### ADDENDUM #1 TO Bid #23-020

BID NUMBER: 23-020

#### **PROCUREMENT FOR: Repair/Replacement of Public Beach Access**

This addendum will amend **Bid #23-020, Repair/Replacement of Public Beach Access** originally issued on Friday, February 17, 2023. This clarification is being provided to all known and registered correspondents in response to questions received. All addenda and original bid documents are also available online at: [www.gtcounty.org](http://www.gtcounty.org), select "Bid Opportunities" from the Quick Links section.

**S1.01**

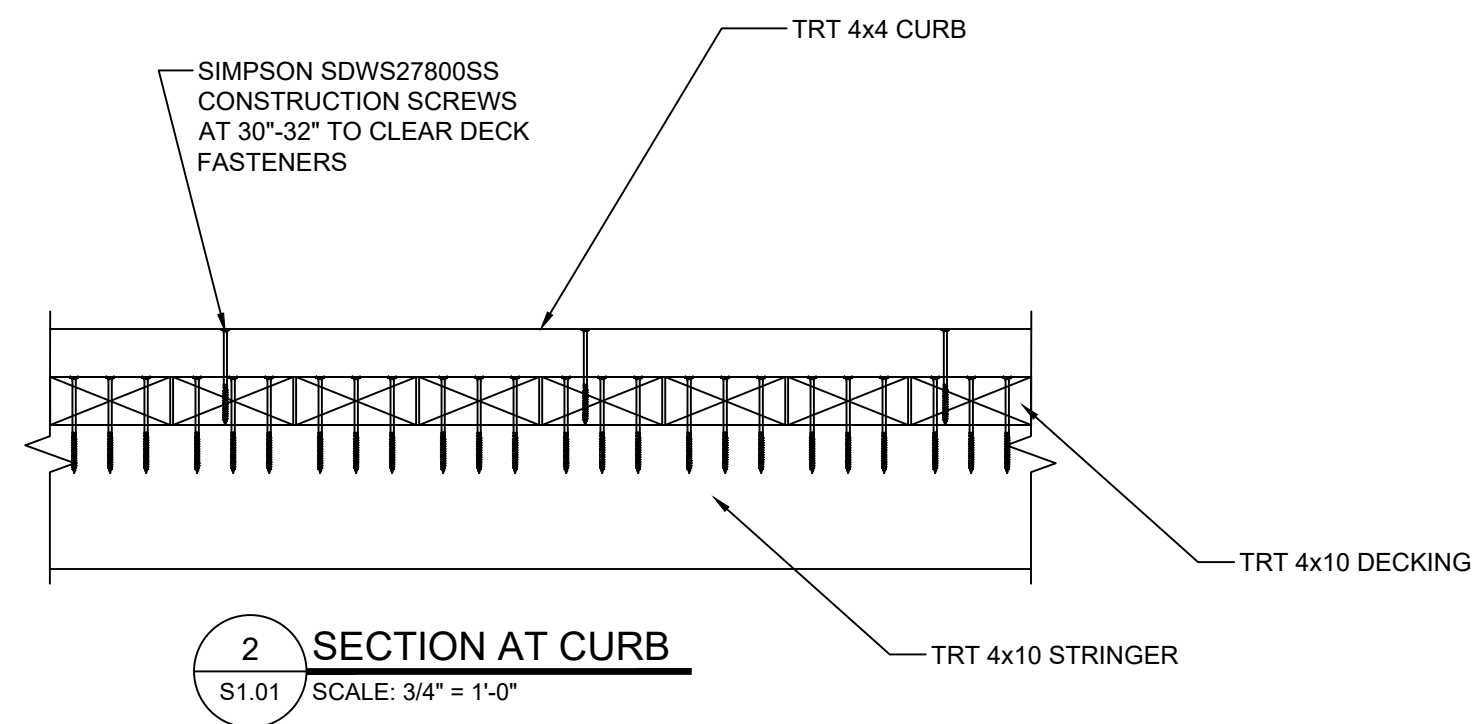
**CHANGE:** See revised drawing S1.01 Driveover Plan attached to replace the one previously issued. This one is identical to #47 which was previously restored.
